Base Load Power Hub (BLPH)

HSSE Action Tracking Register and Close out report

Document Number: 123A90-DDL-SAF-RE-30004

A1 | DRAWING NO. 1724000448-PR-PID-00013 | SHEET 005 | REV. 1

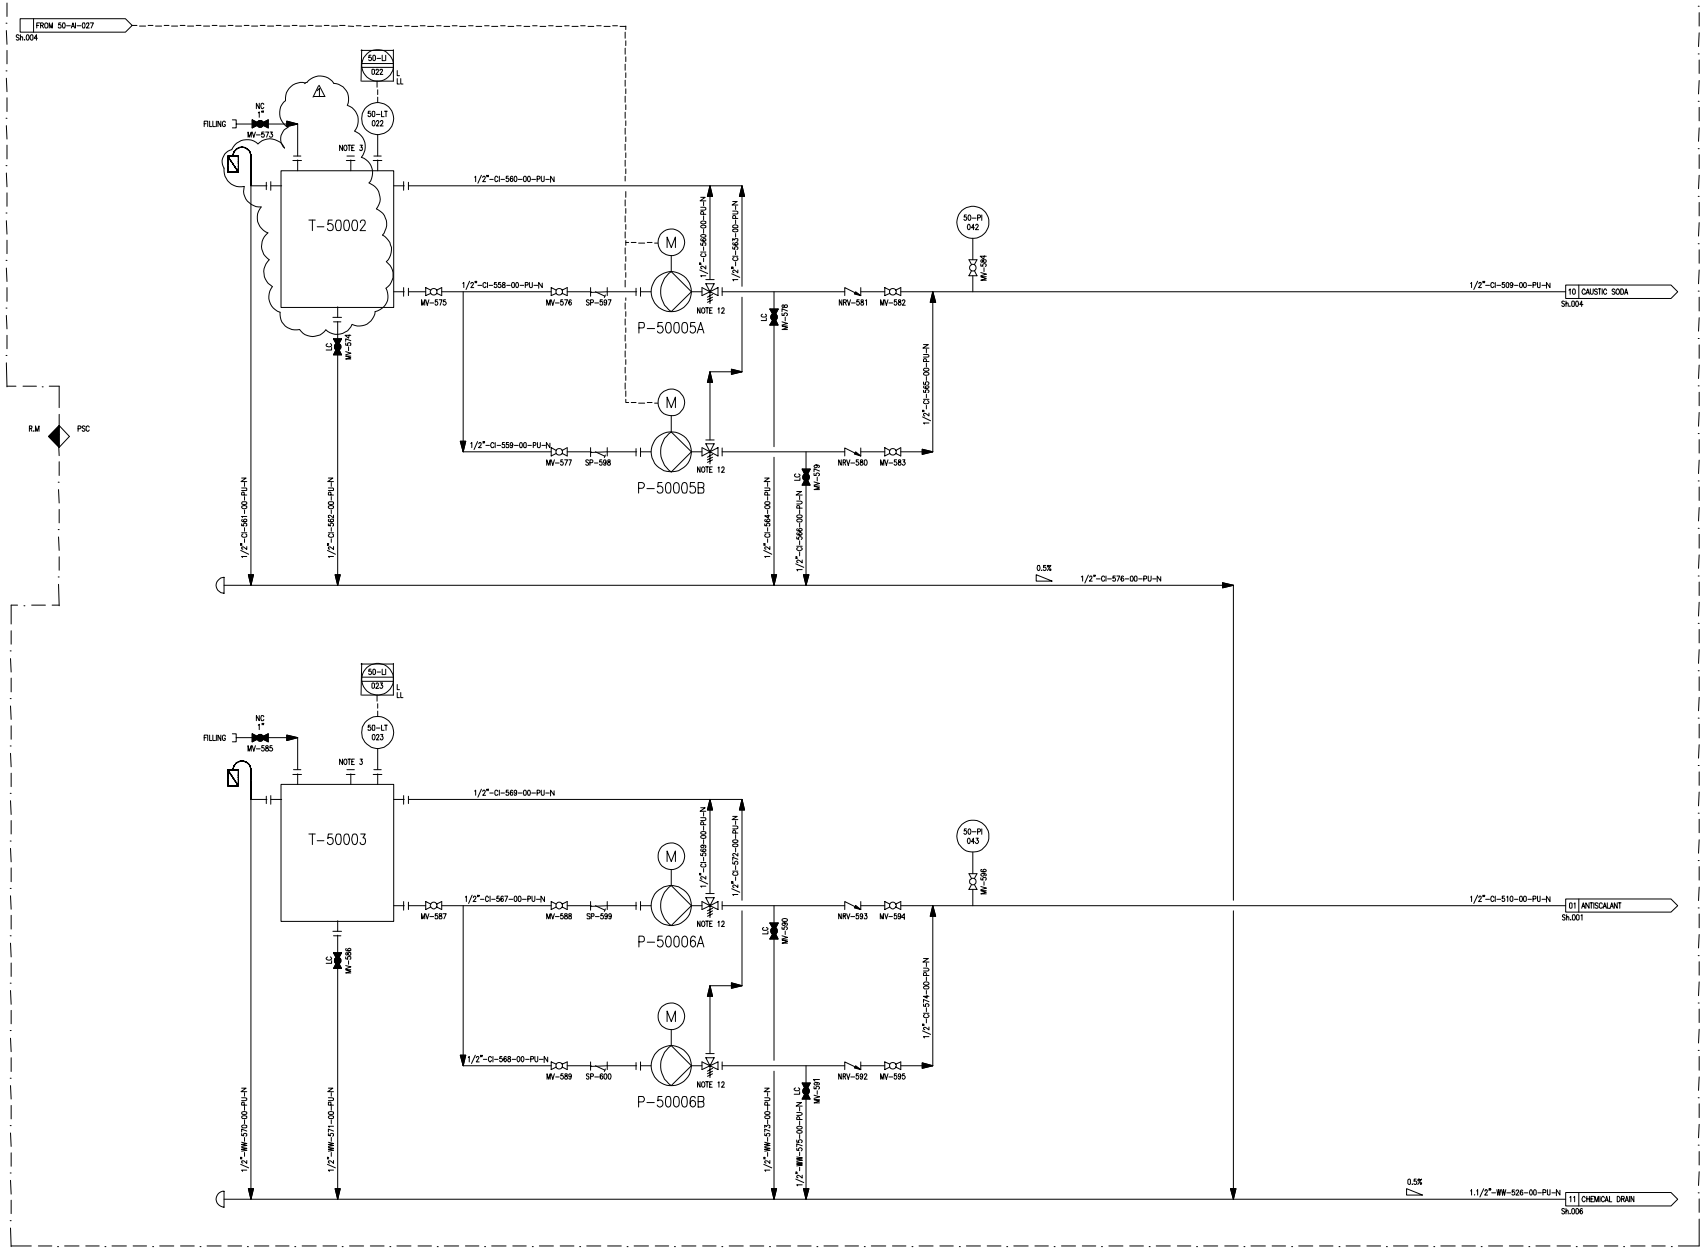
#51	EPC HAZOP	5.3.7. 50-XV023 flushing valve open when not required	5.3.7.1. Linking of T-50006 and T-50008 with potential of contantamination of T-50008 with filtered sea water. Filtered sea water fed forward to electrolysis unit with potential damage to RO unit in electrolysis package.	51. Add an NRV in the flushing water line between T-50008 and 50-XV023 / 50-XV024 to prevent reverse flow in the flushing line and potential contamination of T-50008 with filtered brine from T-50006.	ROSETTI	01/12/2023	Noted. The Check valve NRV-650 have been installed. See PID 1724000448-PR-PID-00013 SHEET 5
